Model: Adonis-C3		Date: 20-May-03	No.: RB082012
Subject: SR790 Finisher Installation		Prepared by: K. Takagi	
From: 1st Tech. Support Sec. Service Support Dept.			
Classification:	<input checked="" type="checkbox"/> Troubleshooting	<input type="checkbox"/> Part information	<input type="checkbox"/> Action required
	<input type="checkbox"/> Mechanical	<input type="checkbox"/> Electrical	<input type="checkbox"/> Service manual revision
	<input type="checkbox"/> Paper path	<input type="checkbox"/> Transmit/receive	<input type="checkbox"/> Retrofit information
	<input type="checkbox"/> Other ()

Subject: Software Release History (SR790)		Prepared by: S. Tomoe	
From: 1st Tech. Support Sec. Service Support Dept.			
Classification:	<input type="checkbox"/> Troubleshooting	<input type="checkbox"/> Part information	<input checked="" type="checkbox"/> Action required
	<input type="checkbox"/> Mechanical	<input type="checkbox"/> Electrical	<input type="checkbox"/> Service manual revision
	<input type="checkbox"/> Paper path	<input type="checkbox"/> Transmit/receive	<input type="checkbox"/> Retrofit information
	<input checked="" type="checkbox"/> Other ()

Model: Russian-C2 1000 Sheet Finisher

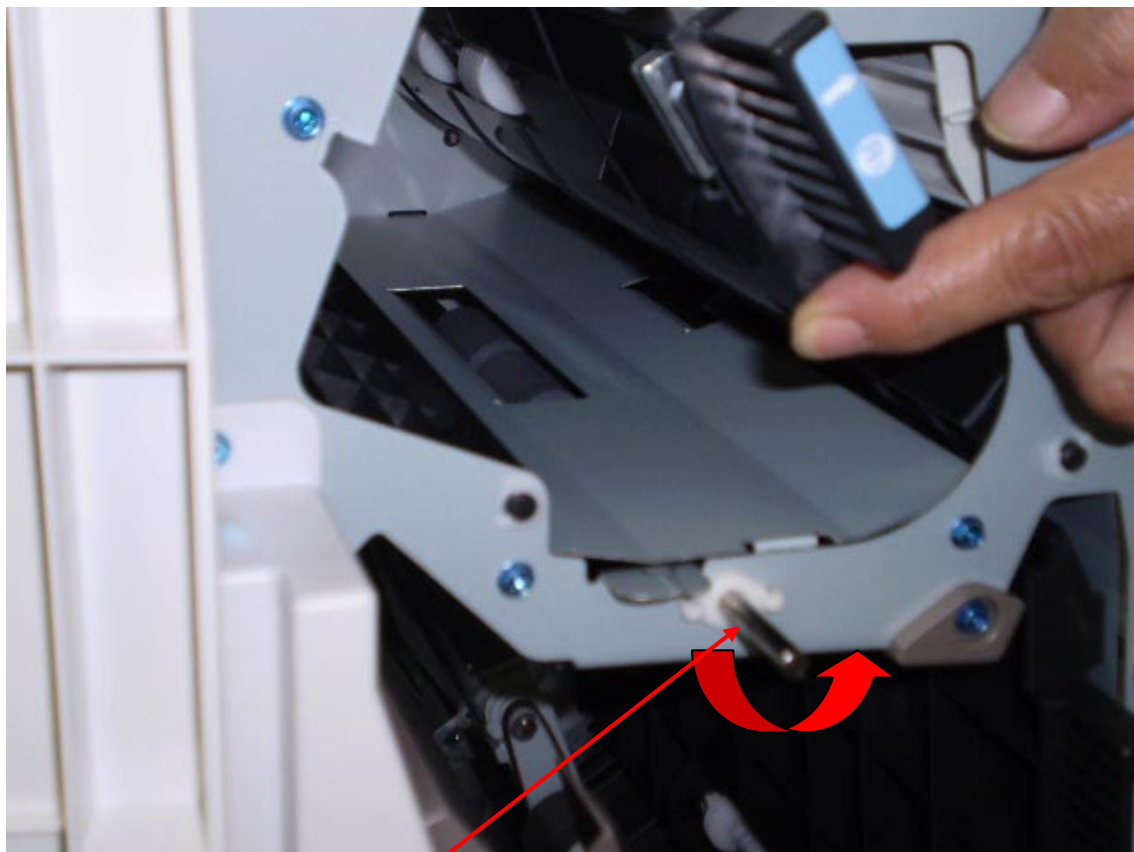
Please rotate the Shift Roller manually before installing the 1000 sheet finisher (SR790). (See the procedure below.) This action confirms that the motor rotates properly and will release a (possibly) stuck motor.

1. Open the front door of the finisher
2. Hold up the guide plate(R1)
3. Rotate the shift roller slowly.

Shift roller

The stepper motor (B4085532) does not rotate because of vaporized glue dried on the motor shaft. (Motor locked).

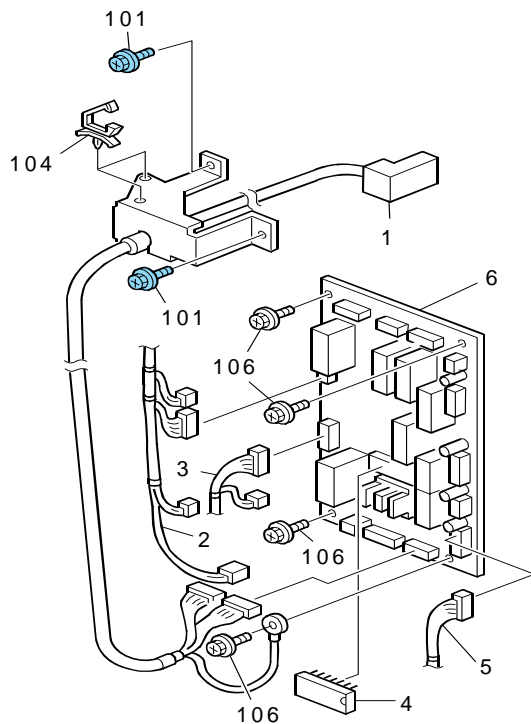
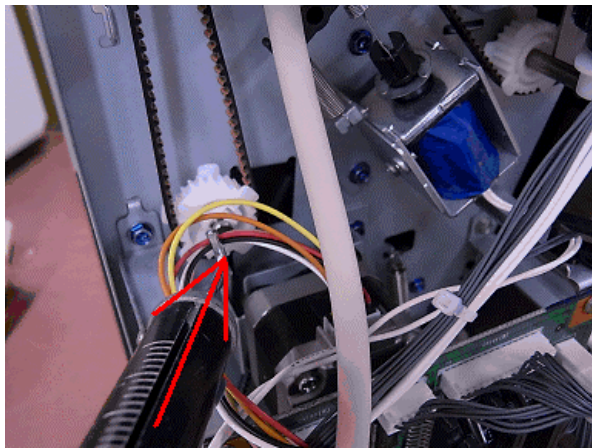
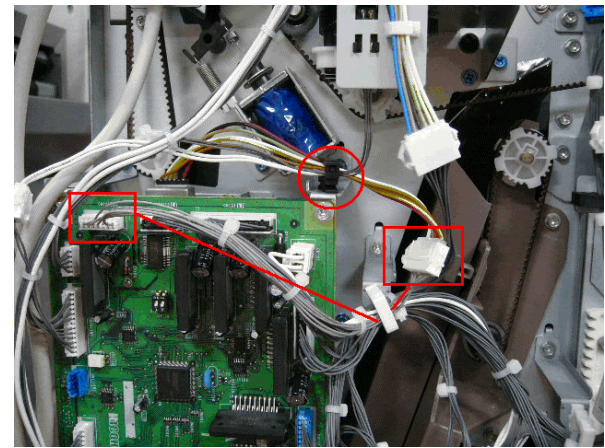
- 1) The shape of the bracket was changed (a clamp was added to the bracket).
- 2) The routing of the harness was changed.

- 1) To prevent the harness from touching the belt.
- 2) To prevent the harness from touching the gear.

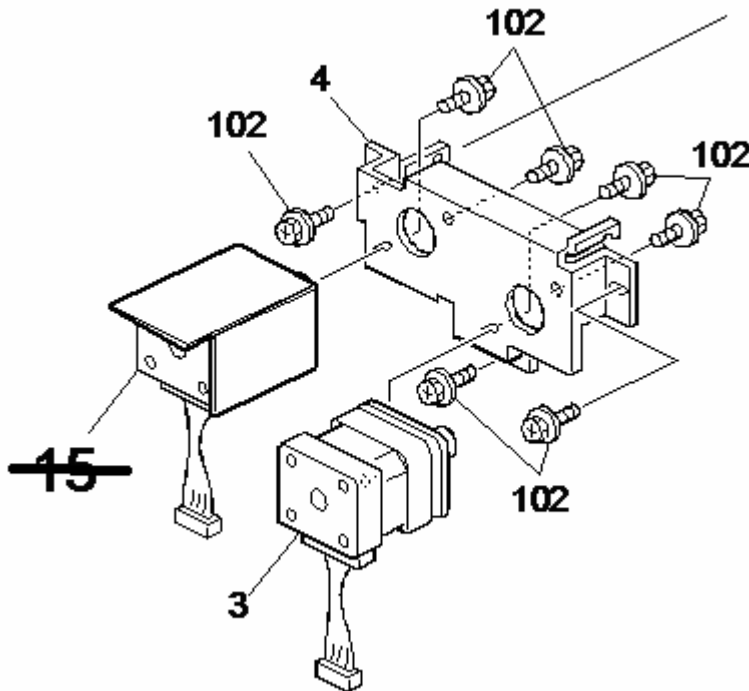
Change: *The heat sink shown was deleted.*

Reason: *It was found that the standards for the machine's internal temperature can be satisfied without this heat sink.*

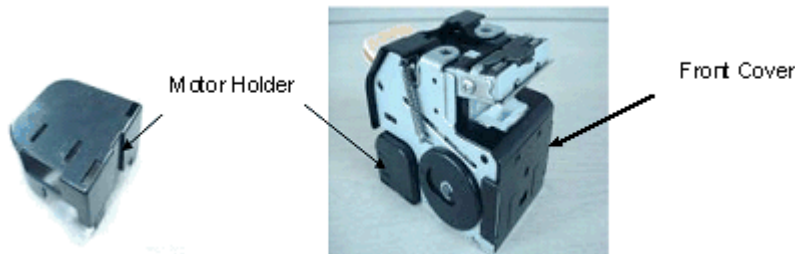
Some parts of the stapler unit (black resin parts shown below) contained PBDE material in excess of the limits set by the RoHS Directive.

The vendor of these parts used irregular materials during the manufacturing process. Production period: June to September 2010 (refer to the S/N table below)

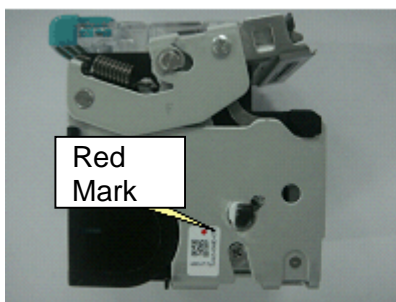
Important: Stapler units on some of these affected finishers have already been replaced with the normal ones. If there is a **red dot** on the stapler unit's label (see the photo below), you **do not need to replace** these units.

Replace the stapler unit.

The affected stapler unit is shown in the illustration below (Index #24):

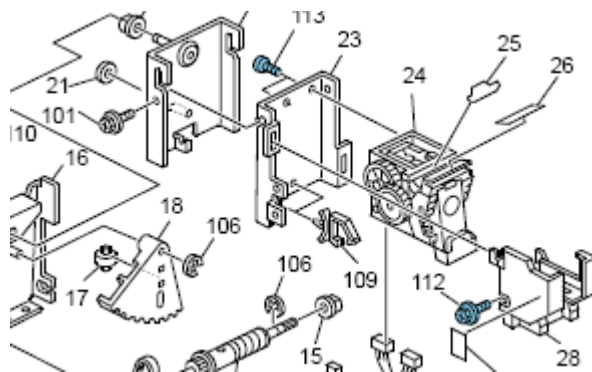
1. These parts contain staplers and Mylars but not cartridges.
2. Stapler units for corner stapling on the affected finishers with the parts that were registered specifically for this issue (also listed below). So, this issue does not apply to booklet stapler units (B7007852), so you do not need to replace these.

Finisher	Stapler unit P/N
SR790	B408 9910
SR3000	B793 9901
SR3050	D372 9901
SR3020*(see note2)	B805 9901
SR3030	
SR4020*(see note2)	
SR4030	
SR4040*(see note2)	
SR3010	B792 9901
Internal Finisher Type C2550	D429 9910
